GE Hitachi Nuclear Energy

MFN 08-232
Supplement 2

Subject: Revised Response to Portion of NRC Request for Additional Information Letter No. 198 Related to ESBWR Design Certification Application – DCD Tier 2 Section 3.7 – Seismic Design – RAI Number 3.7-63 S01

RAI Number 3.7-63 S01 (Revision 1)

Figure 3.7-63(1) Comparison of Surface Response Spectra for Layered Case 2 when the Input Motion is applied at Different Levels

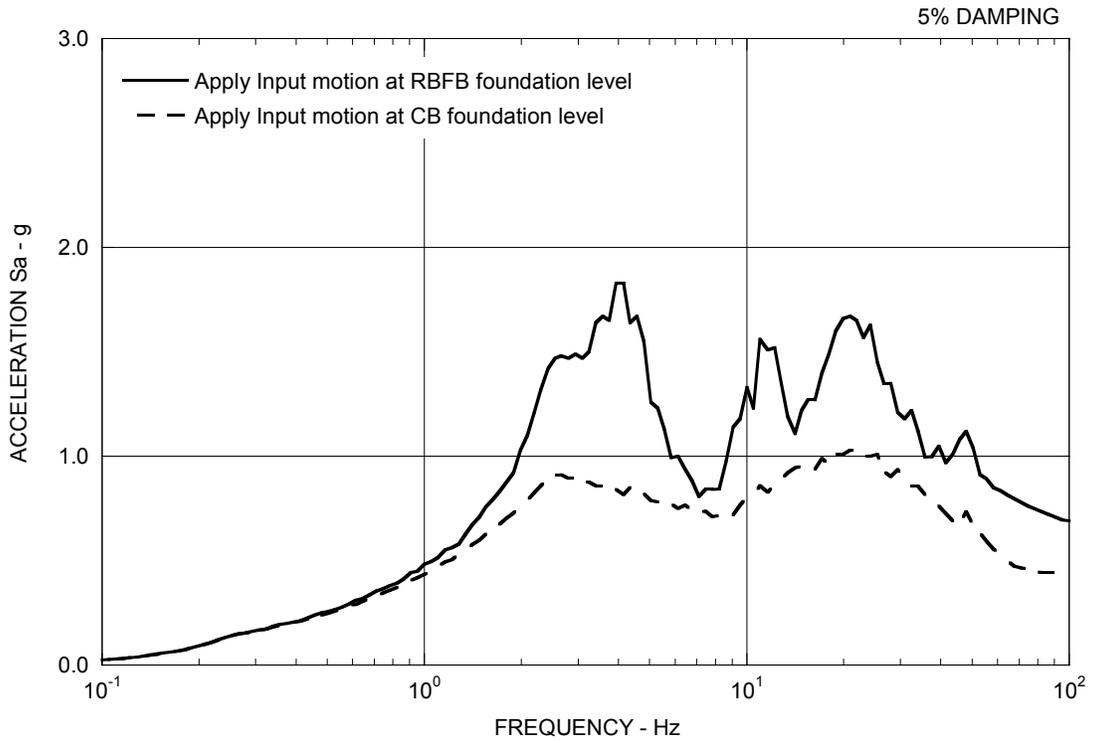
In reviewing Figure 3.7-63(1), the staff noted that the surface spectra corresponding to placing the input motion at the bottom of the CB foundation (dashed line) does not appear to be correct. It resembles the spectrum of the input motion, at the foundation level. The dashed line would be expected to exhibit the same pattern of peaks and valleys as the solid line. GEH needs to confirm that the dashed line is correct, and provide an explanation for the unexpected shape.

GEH confirms that both the solid and dashed lines in Figure 3.7-63(1) have been correctly calculated by using the method identified as the DCD Method in GEH's response to NRC RAI 3.7-16, Supplement 2 transmitted to the NRC via MFN 06-274, Supplement 2, which includes the entire soil column up to the ground surface in a single SHAKE run with outcrop motion input at the foundation level.

The reason for the dashed line resembling the foundation input spectrum is because the CB (14.9 m embedment) is shallower than the top layer (20m thick) of the layered sites (see DCD Tier 2 Table 3A.3-3). In other words, the soil properties above the foundation are the same as those below the foundation in the region of the top layer and, as a result, the surface motion resembles the foundation input motion. This can be further explained by the one-dimensional wave propagation theory below:

Figure 3.7-63(2) Comparison of Horizontal SSE Design Response Spectrum with NA3 Site-Specific Spectra at FWSC Foundation Level (Reproduced from North Anna 3 COLA FSAR Figure 2.0-203)

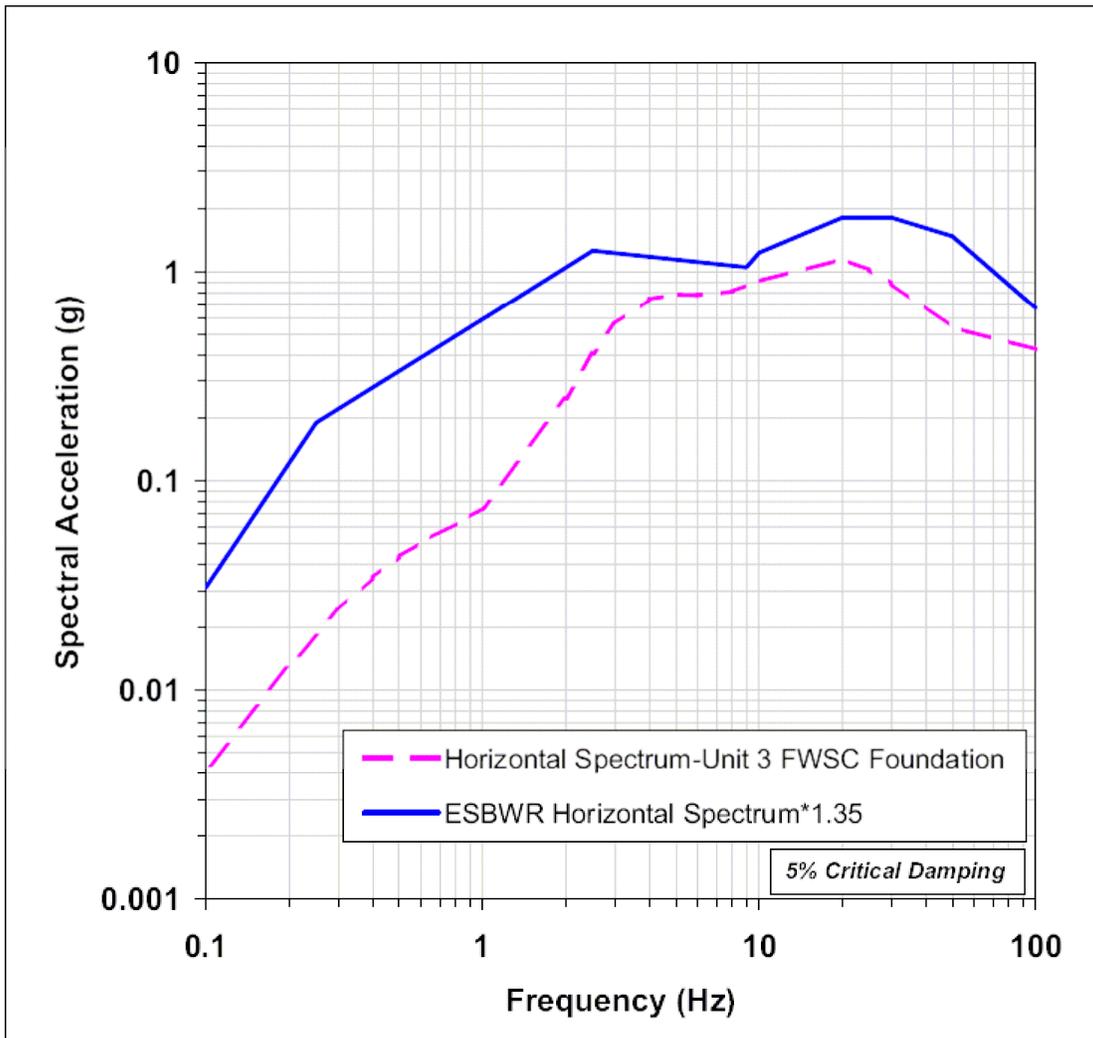
The staff believes that the surface spectra used for seismic analysis of the FWSC should envelope the 8 surface spectral plots that the staff has asked GEH to derive under Part (1) above. This would ensure consistency between the input at the RB/FB and CB foundation levels and the input at the surface for the FWSC. GEH's proposed 1.35 factor on the input motion at the bottom of the RB/FB foundation may or may not produce a suitable envelope. Based on comparing Figure 3.7-63(1) to Figure 3.7-63(2), it appears to the staff that a 1.35 factor may not be sufficient over the entire frequency range.

Part (2) - The surface spectra computed from the input spectra defined at the RB/FB and CB foundations, as shown in Figures 3.7-63(4) through 3.7-63(7), exhibit distinct peaks and valleys. Using these surface spectra directly as input motion could under-predict or over-predict the FWSC response depending on the SSI frequencies. The more balanced approach for the standard plant design is to maintain the broad-band characteristics in the foundation input spectra that is rich in all frequencies, regardless of site conditions. This is the technical basis for the selection of FWSC input spectra to be 1.35 times the broad-band Certified Seismic Design Response Spectra (CSDRS) for the RB/FB and CB. As stated in the original response to this RAI, the 1.35 scale factor was chosen to envelop the FWSC Foundation Input Response Spectra (FIRS) at the North Anna 3 site. To ensure the seismic adequacy of the FWSC at each site, the COL applicant is required to compare the site-specific FIRS for the FWSC with the FWSC CSDRS, which is 1.35 times the values shown in DCD Tier 2 Figures 2.0-1 and 2.0-2 as stipulated in footnote 9 to DCD Tier 2 Table 2.0-1.

Figure 3.7-63(4) Comparison of Surface Response Spectra for Layered Case 1

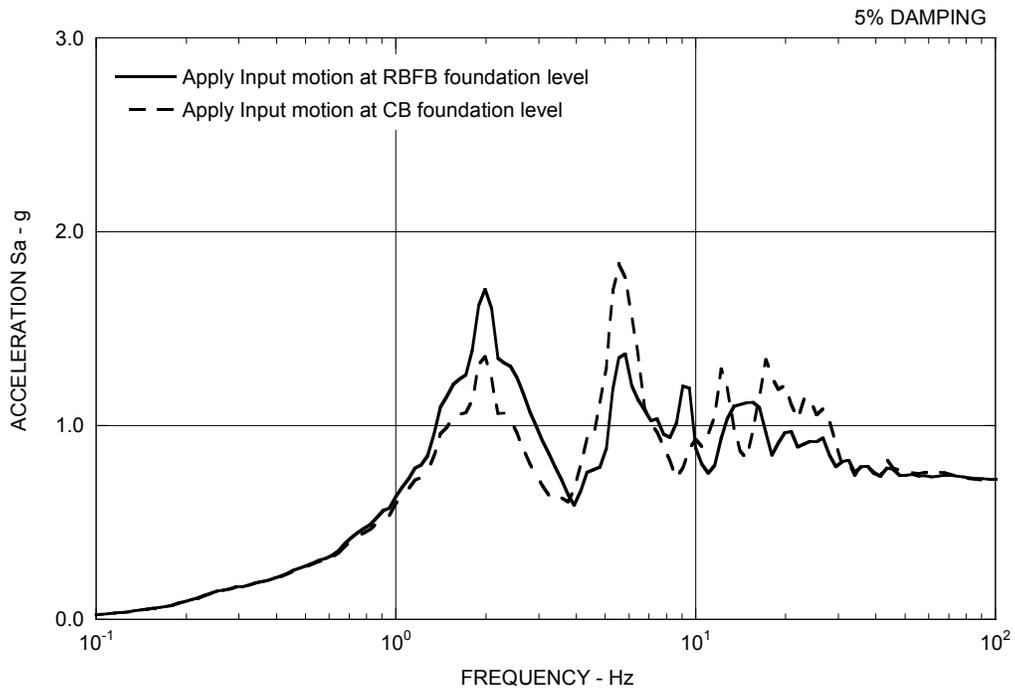
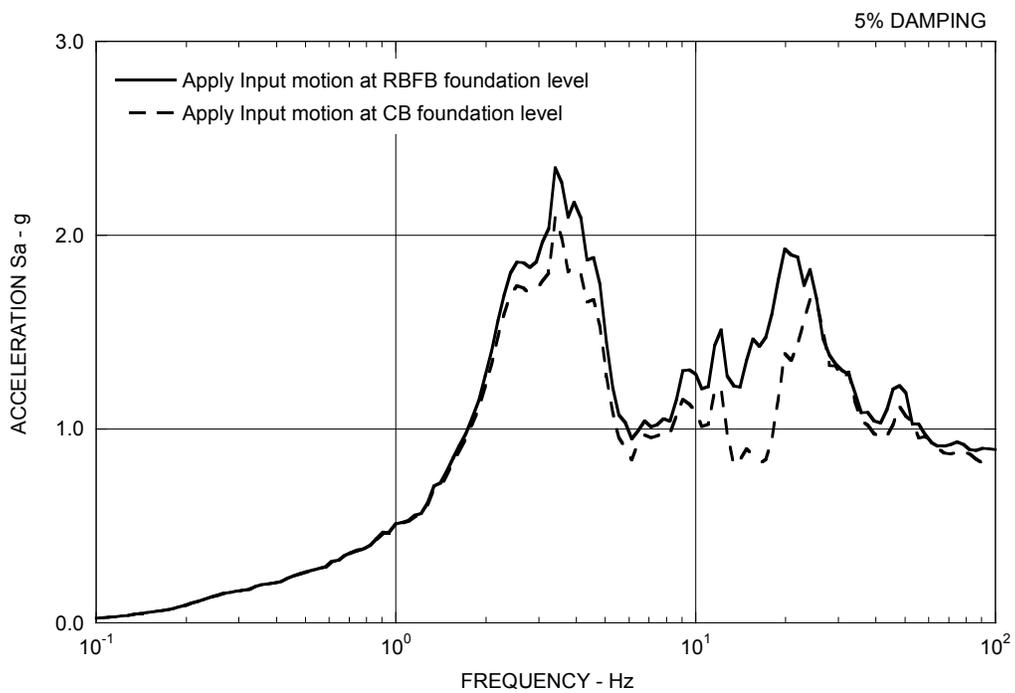
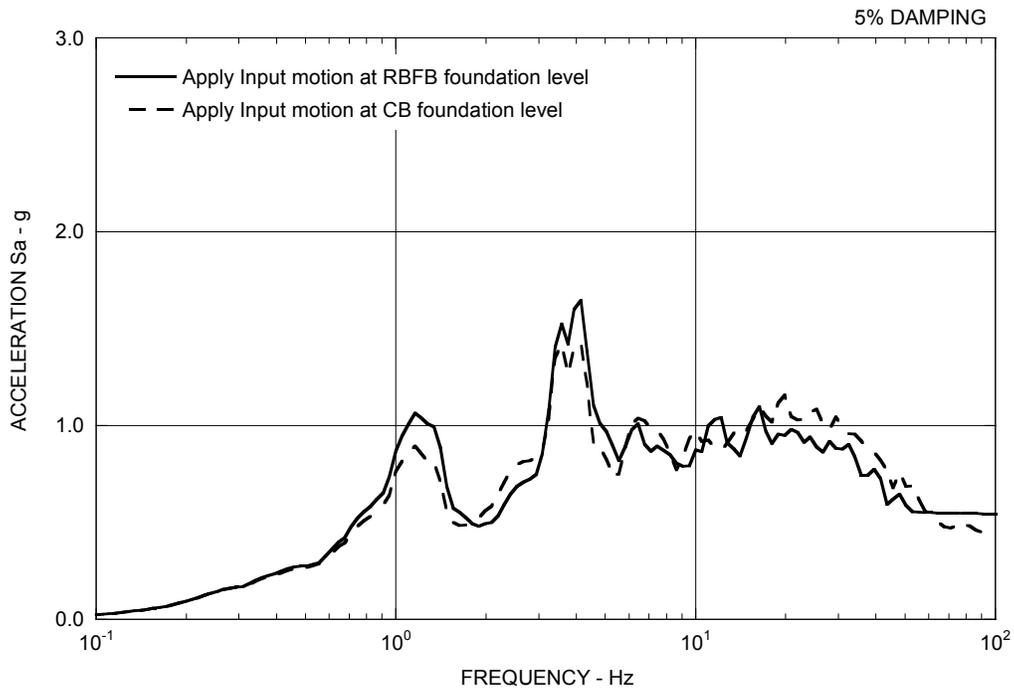
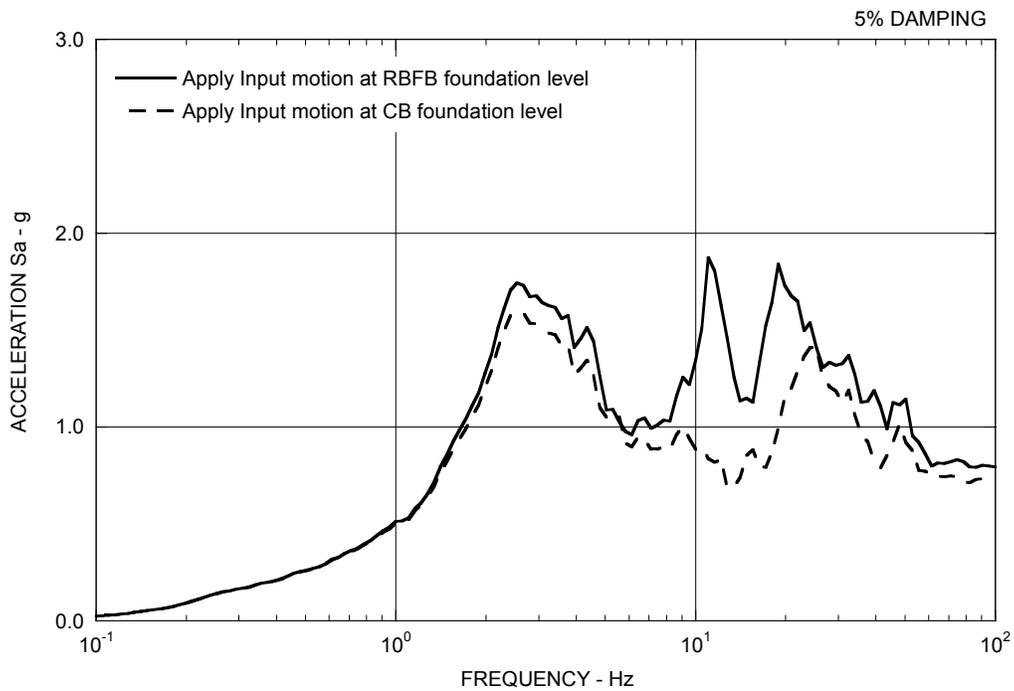
Part (1) - GEH needs to submit a comparison of the surface spectra derived by placing the input motion at the bottom of the RB/FB foundation to the surface spectra derived by placing the input motion at the bottom of the CB foundation, for each of the 4 SASSI layered soil cases. In deriving the surface spectra from the foundation motions, the method identified as the NRC method in GEH's response to RAI 3.7-16 must be used. Submit four (4) figures, similar to Figure 3.7-63(1).

Part (1) - Figures 3.7-63(4) through (7) show comparisons of the surface spectra derived by placing the input motion at the bottom of the RB/FB foundation to the surface

spectra derived by placing the input motion at the bottom of the CB foundation for each of the 4 SASSI layered soil cases by using the method identified as the NRC Method in GEH's response to NRC RAI 3.7-16, Supplement 2 transmitted to the NRC via MFN 06-274, Supplement 2.

Since the fundamental frequencies of the CB in the horizontal directions are around 3 Hz, as shown in DCD Tier 2 Table 3A.7-8, the CB responses would be smaller for all layered site cases if the input ground motion had been applied at the CB foundation level instead at the RB/FB foundation level.
